SERVICE INFORMATION LETTER

OXYGEN - ATA CHAPTER 35

NEW FAA RULE FOR 5600 SERIES, 9800 SERIES AND OTHER PORTABLE CYLINDER ASSEMBLIES

Figure 1
Replacement Instruction Label P/N 10009071

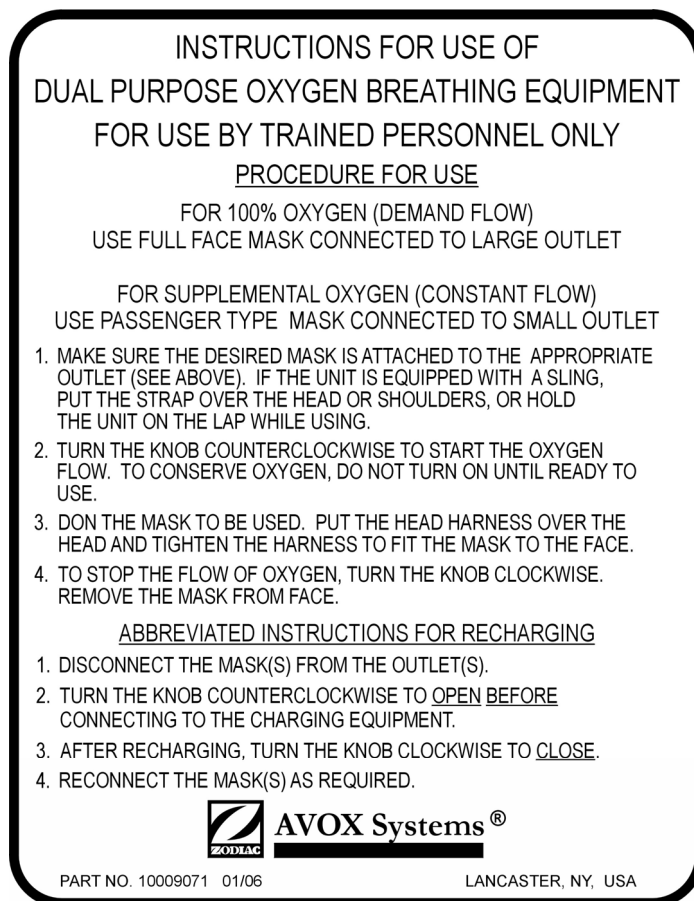
- B. In order to comply with this FAA Rule, at least one mask must be connected to a PCA that is positioned for use onboard an aircraft covered by this rule. It is recommended that PCA's used on aircraft covered by this rule that were manufactured by AVOX Systems before April 1, 2006 be labeled with the new procedure for use. The application of replacement labels as described in this SIL is voluntary, but recommended. The replacement Instruction Labels are available free of charge from AVOX Systems (see page 5).

This SIL applies to all PCA's listed in Table 1 that were manufactured before April 1, 2006. If your PCA has a yellow transparent label P/N 10009071, this SIL applies. The new labels are black print on silver. The text of the new label is shown in Figure 1.

- E. Carefully affix a replacement Instruction Label (P/N 10009071 01/06) shown in Figure 1 in the area shown in Figure 2 with the text in the same orientation as the previous Instruction Label. If the existing Instruction Label is clean and firmly adhered, the new label can be affixed over it. Make sure that the Instruction Label is tightly adhered to the cylinder by firmly rubbing with your clean hand or a clean cloth.

Figure 2
Placement of Label on Cylinders

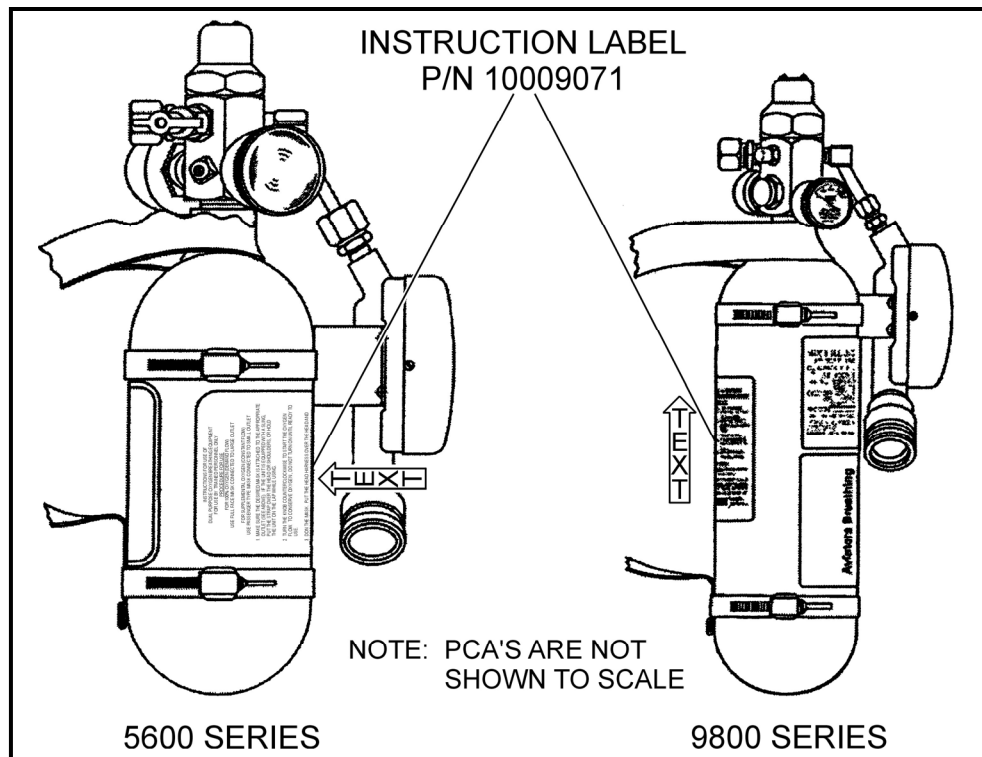
- C. For each PCA you want to re-label, only remove the existing Instruction Label if loose or damaged, (Figure 2 shows the location).
- D. Use soap and water to clean the existing label or the area on the cylinder from where the Instruction Label was removed. Make sure the area is dry and free of soap before the new label is affixed.
